Project for:
THE CHURCH OF JESUS CHRIST OF LATTER-DAY SAINTS

Sheet Title:
SITE CIVIL DETAILS

Sheet:
C701

K ASPHALT PAVING
1" = 1'-0"

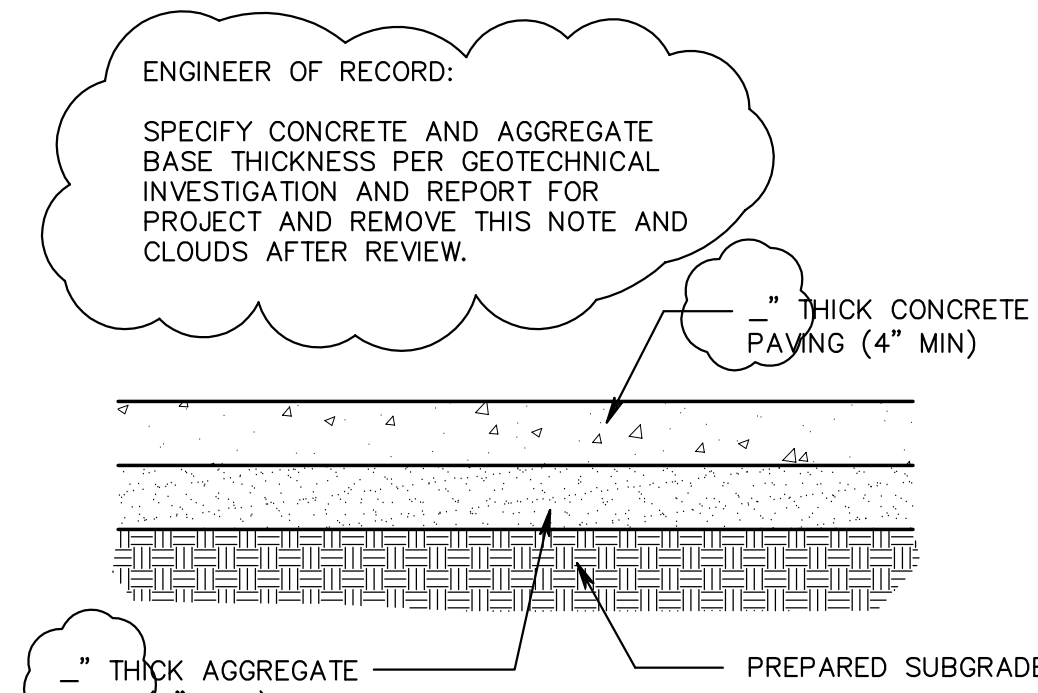
ENGINEER OF RECORD:
SPECIFY ASPHALT AND AGGREGATE BASE THICKNESS PER GEOTECHNICAL INVESTIGATION AND REPORT FOR PROJECT AND REMOVE THIS NOTE AND CLOUDS AFTER REVIEW.

L CONCRETE PAVING
1" = 1'-0"

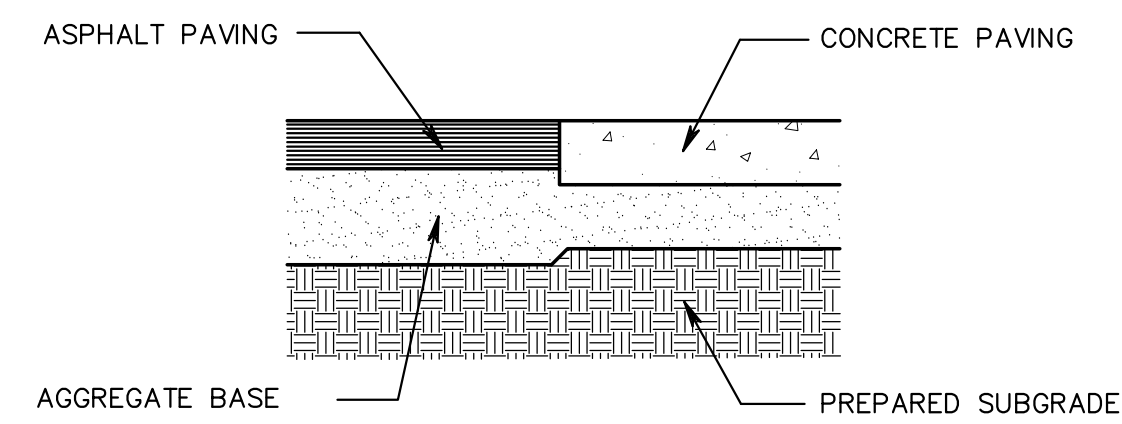
ENGINEER OF RECORD:
SPECIFY CONCRETE AND AGGREGATE BASE THICKNESS PER GEOTECHNICAL INVESTIGATION AND REPORT FOR PROJECT AND REMOVE THIS NOTE AND CLOUDS AFTER REVIEW.

S BICYCLE RACK
Not to Scale

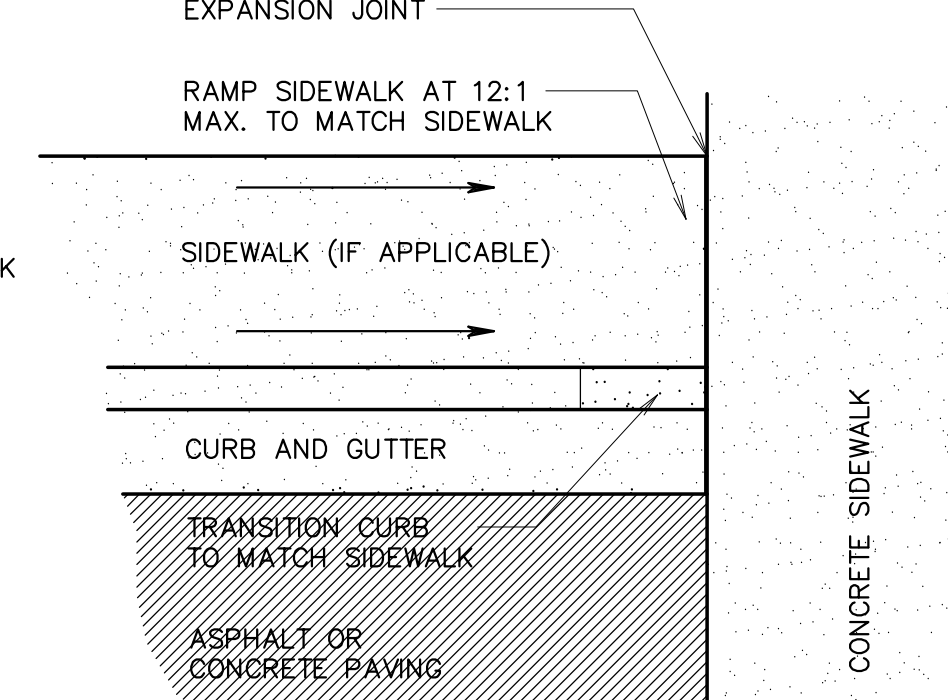
ENGINEER OF RECORD:
ARCHITECT TO DETERMINE NUMBER OF BICYCLES REQUIRED AND SIZE BIKE RACK TO MATCH, THEN REMOVE THIS NOTE AND CLOUDS AFTER REVIEW.
